***Lot 2 DP 748682
132-138 Killeaton Street, St Ives***

***MP10_0057 MOD 5 – Modification to
Approved Monastery Building***

Director-General's
Environmental Assessment Report
Section 75W of the
Environmental Planning and Assessment Act 1979

February 2012

Figure 4: Proposed ground floor plan providing all of the community facilities on the ground floor. The proposal includes two residential units on the first floor (Figure 5).

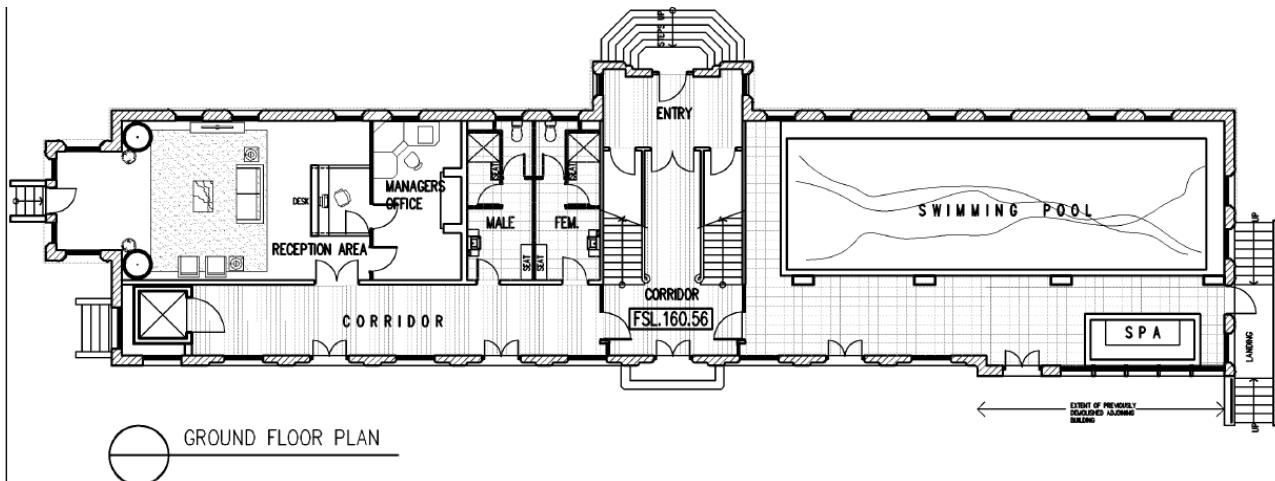
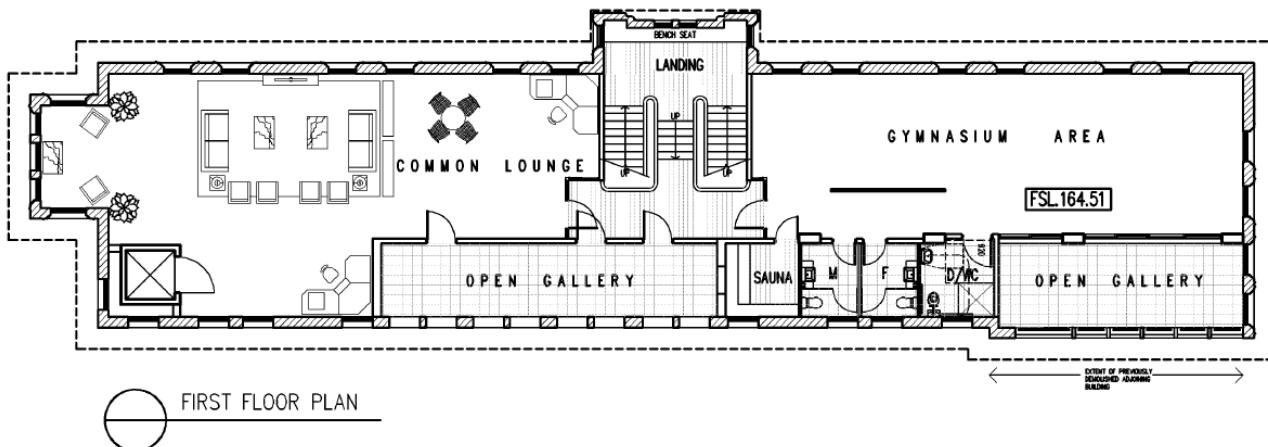
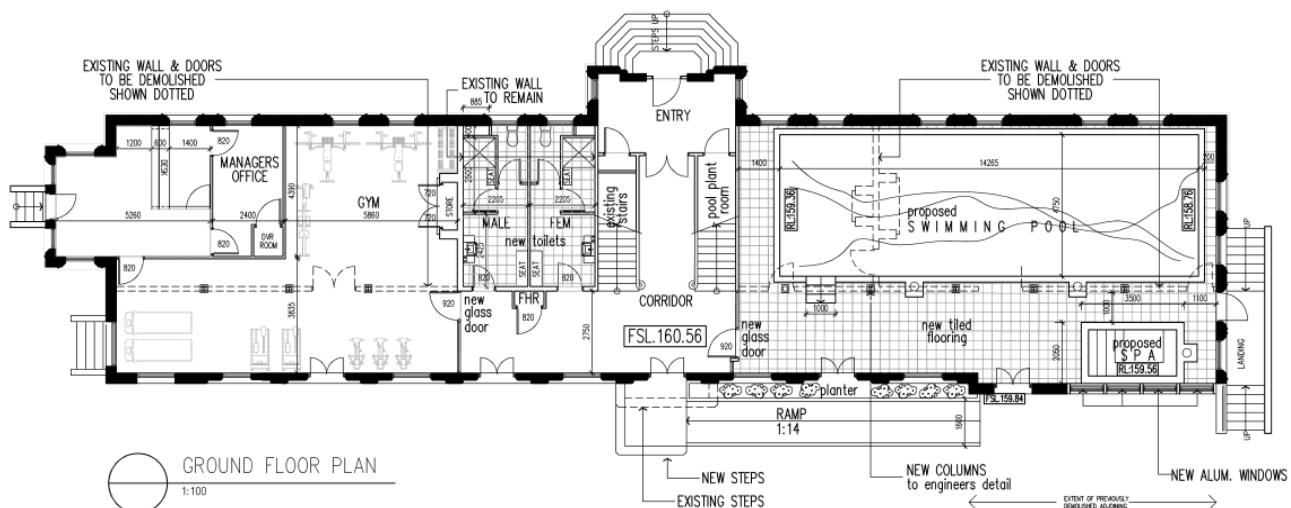
The proposal is for modifications to the layout of the approved communal facilities within the Monastery building to provide all of the communal facilities on the ground floor as demonstrated in **Figures 2, 3 and 4** below.

The department notes that the proposal retains the previously approved facilities, with the exception of three bathrooms, a sauna, a common lounge area, and two open gallery areas. It is also noted that the proposed manager's office, reception area and gym area are reduced in size. The department considers that the rationalisation of the proposed facilities to the ground floor provides usable community facilities which satisfy the needs of future residents, in conjunction with the approved common open space. The communal facilities are available for the use of all

residents, are considered to satisfactorily service the needs of the residents and are supported by the department.

Figure 5: Proposed first floor plan. The proposal is for 1 x 3 bedroom unit and 1 x 4 bedroom unit.

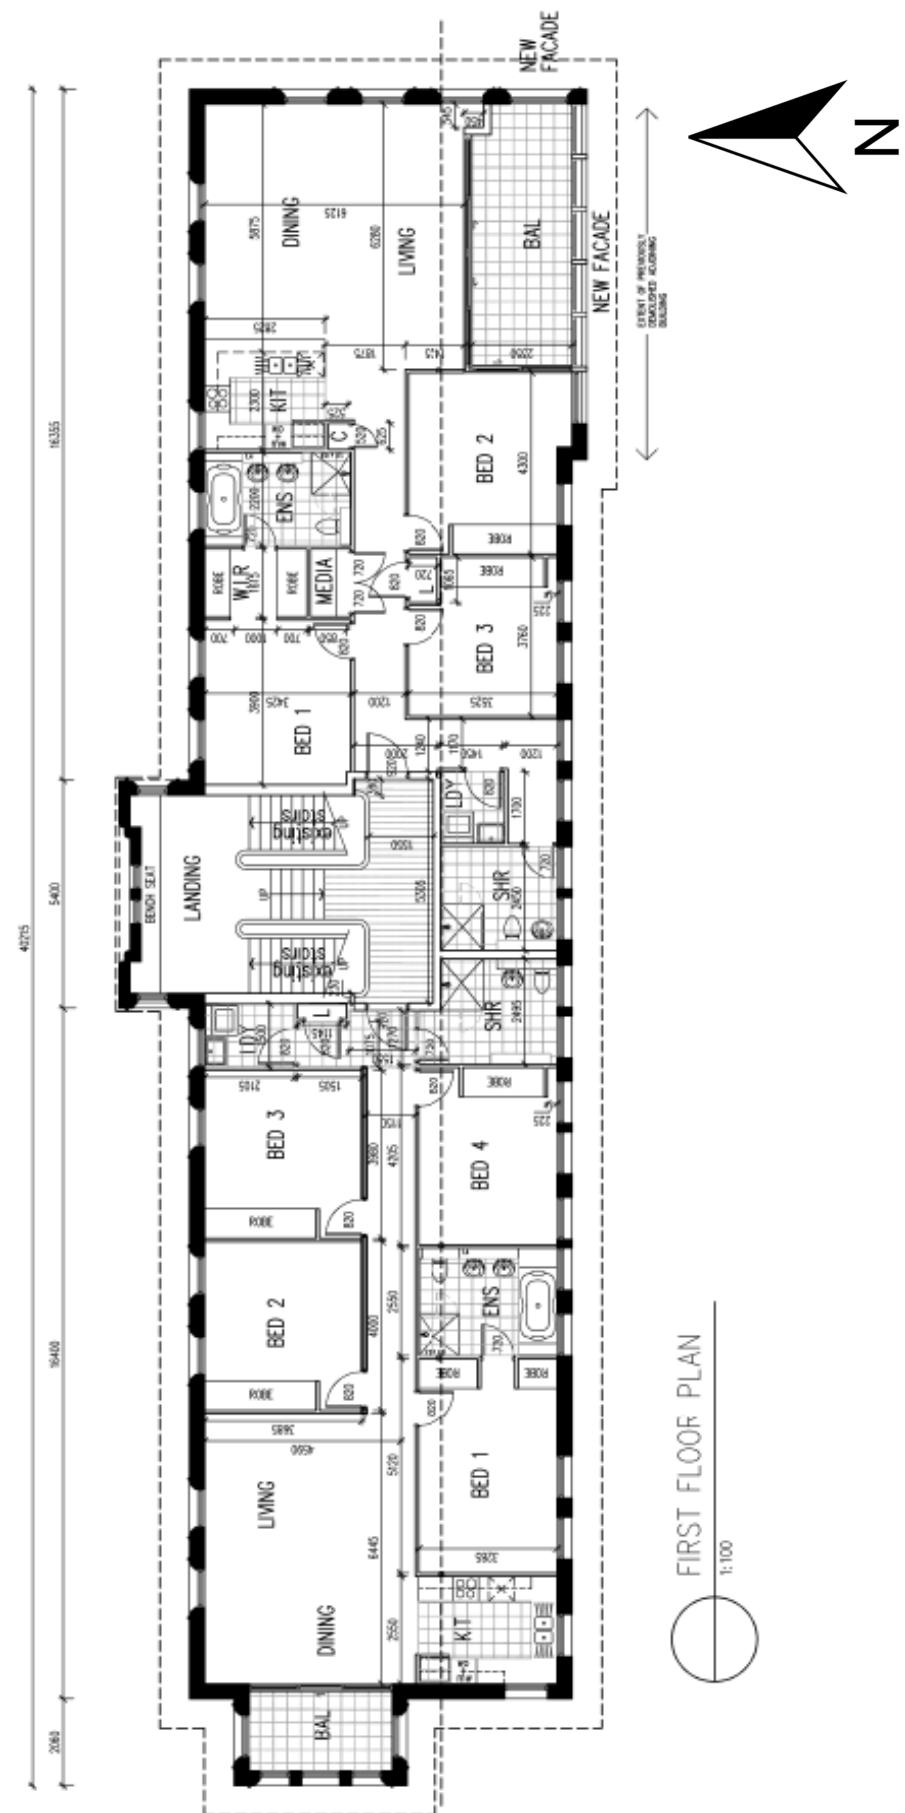
The proposal is for the adaptive re-use of the existing Monastery building to provide 1 x 3 bedroom and 1 x 4 bedroom apartments on the first floor (**Figure 5** below). The proposed residential units are accessible by the central corridor on the ground floor of the building, which is shared with one of the four access points to the proposed ground floor communal facilities. As discussed in Section 5.2 below, the parking levels are accessed via Block C located to the north of the Monastery Building (**Figure 6**).

The Council also raised concern that the existing balcony on the western side of the building is undersized and does not provide sufficient residential amenity for this four bedroom unit (**Figure 5**). The dimensions of the existing balcony are 4.05 metres (width) x 2.06 metres (depth) with an area of 8.343m². The department considers the adaptive re-use of the existing balcony to be an appropriate method of private open space for this unit as it satisfies the intent of the Residential Flat Design Code with respect to balconies as the design maintains the external appearance of the building and it provides usable private open space accessible from the main living areas. The proposed units also have access to the community facilities on the ground floor and the common open space area that adjoins the Monastery building. These measures are considered to complement the private open space provided by the balcony areas of the proposed units and are supported by the department.

The proposed residential units reflect the intent of the Residential Flat Design Code and will provide dwellings with usable balconies, solar access and privacy.

The department supports the proposed adaptive re-use of the first floor of the Monastery building which is considered to be an appropriate use that provides residential units with acceptable residential amenity.

Figure 6: Site Plan demonstrating the location of the existing Monastery building and the lift access to the parking levels via Block C.

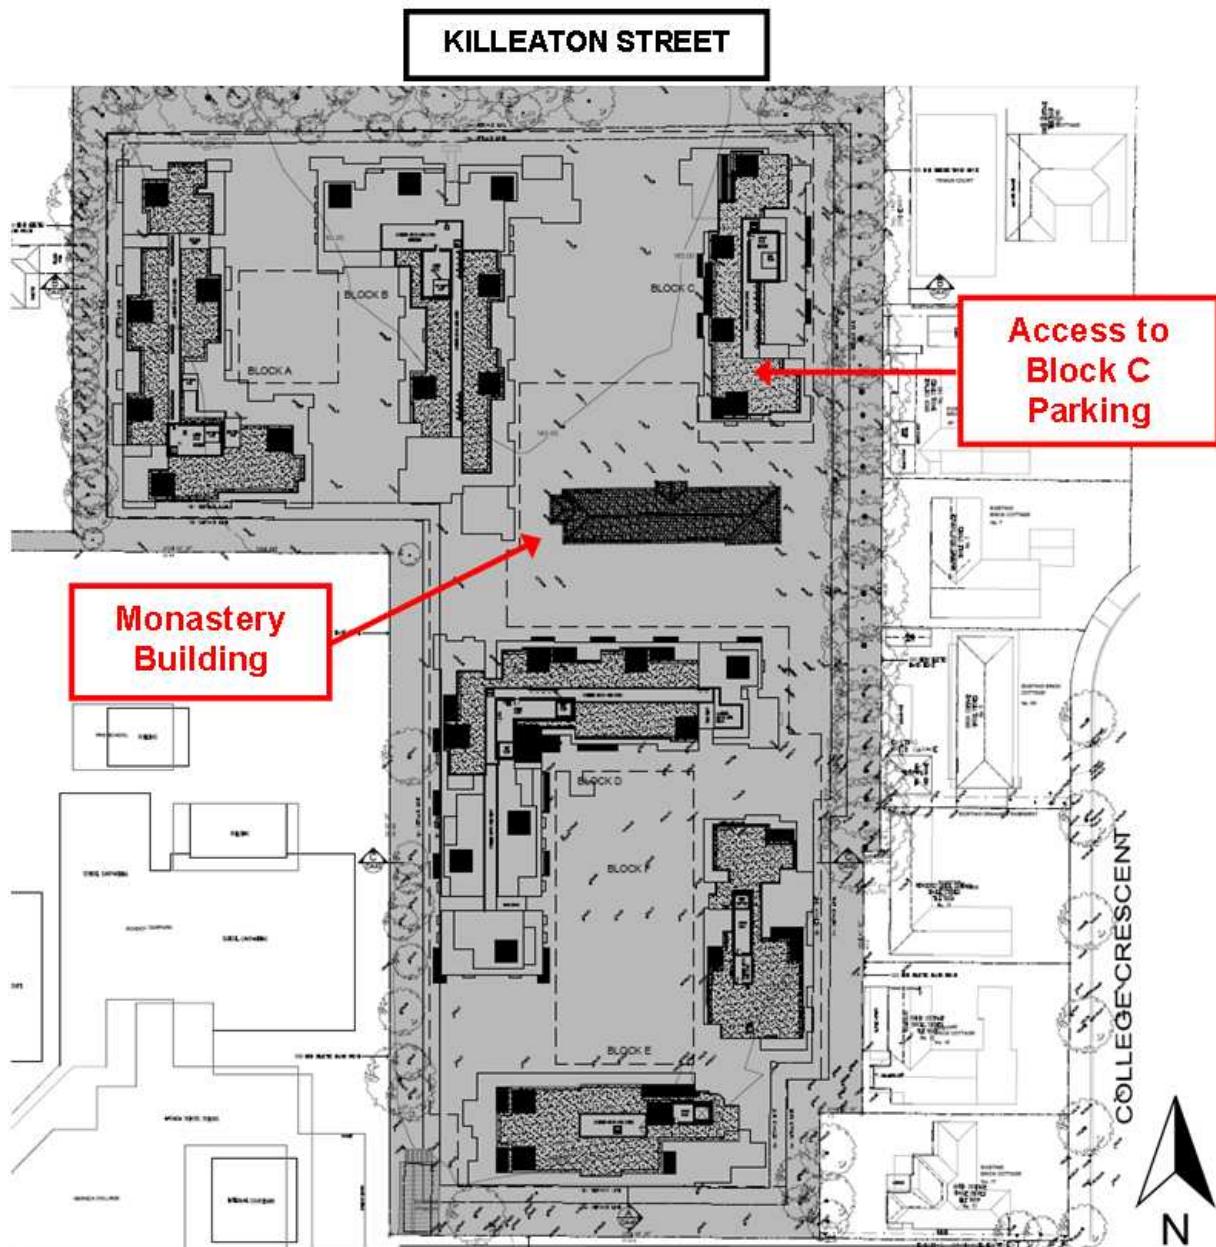
The proposed parking spaces allocated for the Monastery residential units are located near the lift to Block C and the future residents are required to access the Monastery building by walking from Block C (**Figure 6**). The department considers the proposed parking to be suitably located for the use of residents and satisfies the parking demand of the proposed residential units.

Figure 9: Proposed western elevation of the Monastery building. As indicated in red, this elevation shows the western facing windows of the existing balcony. As per Condition C3, the lower half of these balcony windows are to be obscure glazing to prevent overlooking.

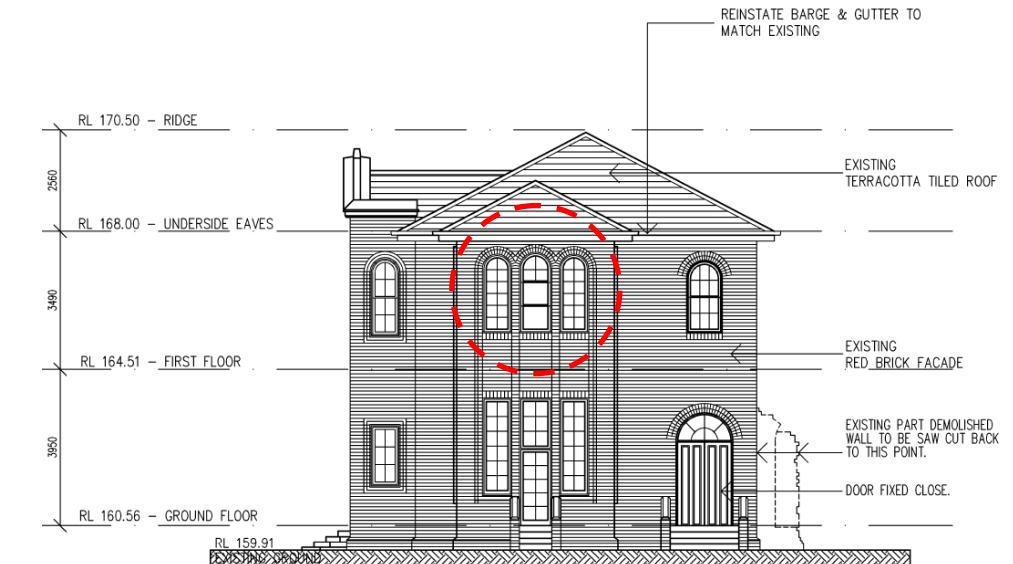
In response to concerns raised by Ku-ring-gai Council, the proponent has offered to provide obscure glazing to the lower half of the west-facing windows of the balcony of the four bedroom unit. The department considers this measure to be sufficient in reducing the potential impact of overlooking the adjacent Block F and protecting the privacy and amenity of the unit within the Monastery building. This is reflected in Condition C3 'External Materials and Finishes (existing monastery building)' of the attached Recommended Modifying Instrument.

Figure 8: Proposed southern elevation of the Monastery building. As indicated in red, this elevation shows the full-length windows on both levels which replace the portion of the building which adjoined a previously demolished part of the building.

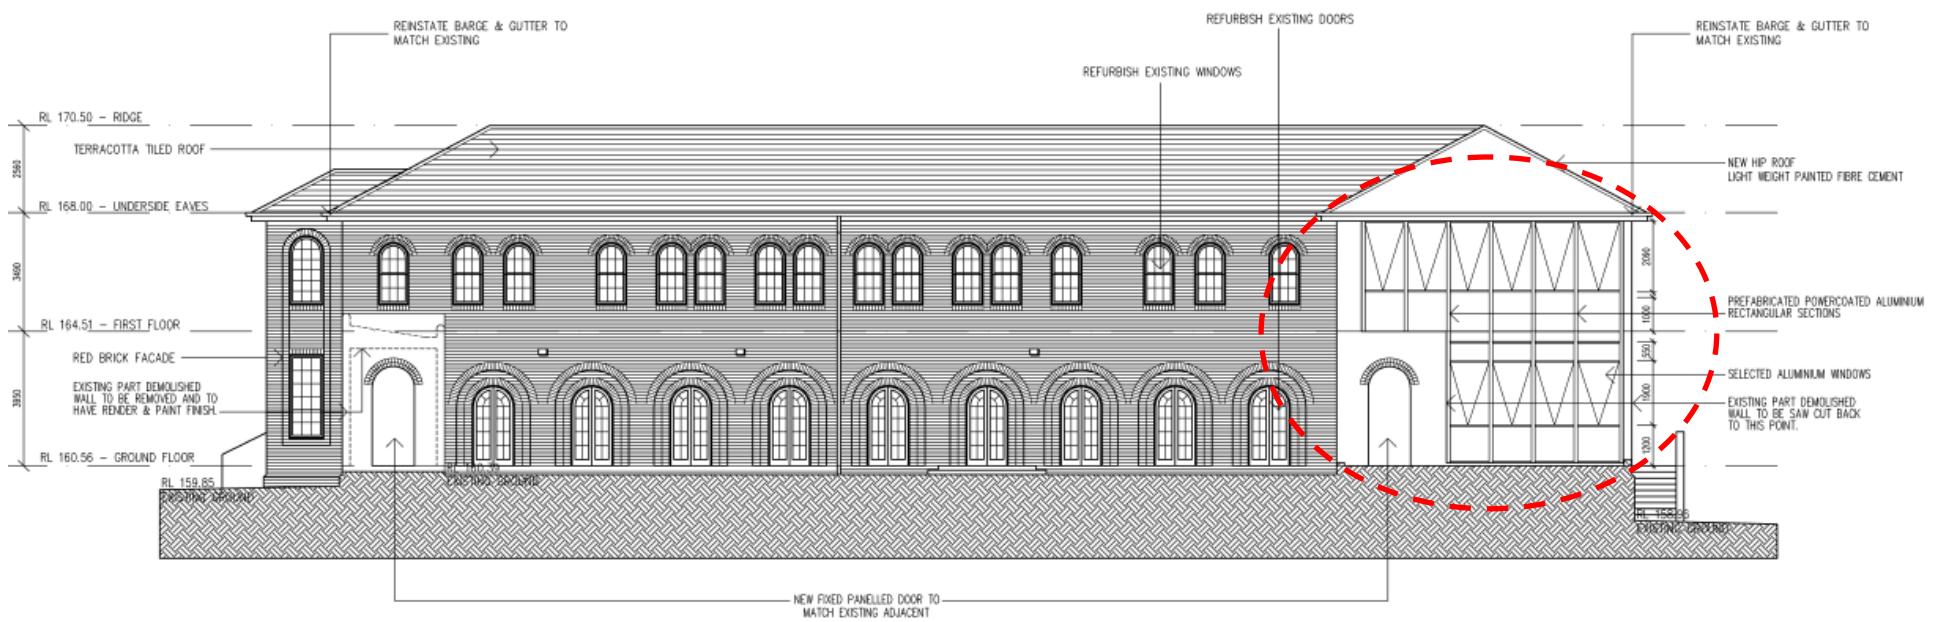
The proposed modifications result in minimal alteration to the external appearance of the existing Monastery building as previously approved. It is noted that the site is not listed as an item of environmental heritage in the *Ku-ring-gai Planning Scheme Ordinance*, and there are no other heritage listings associated with the site. Part of the southern elevation features full-length windows which differ to the design of the remainder of the building, however it is noted that this design was approved in the Project Approval (MP10_0057) and is proposed to be retained (**Figure 8**). This portion of the external façade was previously demolished in conjunction with a wing of the original building. As discussed in Section 5.1.2 above, the proponent has offered to provide obscure glazing to the lower half of the existing balcony windows on the first floor of the western elevation to prevent overlooking the adjacent residential unit (**Figure 9**).
